Comment Report

Project Name: 2016-04 Modifications to PRC-025-1 | PRC-025-2
Comment Period Start Date: 7/25/2017
Comment Period End Date: 9/8/2017
Associated Ballots: 2016-04 Modifications to PRC-025-1 PRC-025-2 IN 1 ST

Figure I4-2 depicts a dispersed generation site and substation design with unknown collector system configuration.

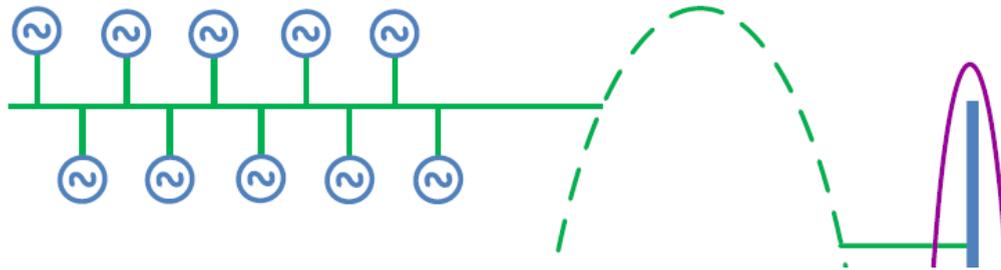
Typical dispersed generation site and substation design (single transformation of voltage level) with a gross aggregate nameplate rating of 80 MVA (Individual Generator Unit Rating: 2 MVA). By application of Inclusion I4 the dispersed power producing resources and the Elements from the point of aggregation to the common point connection are BES Elements.

Green indicates the portions of the Collector System that are not included in the BES.

Blue identifies the dispersed power producing resources and BES Elements between the point where those resources aggregate to greater than 75 MVA to a common point of connection at a voltage of 100 kV or above.
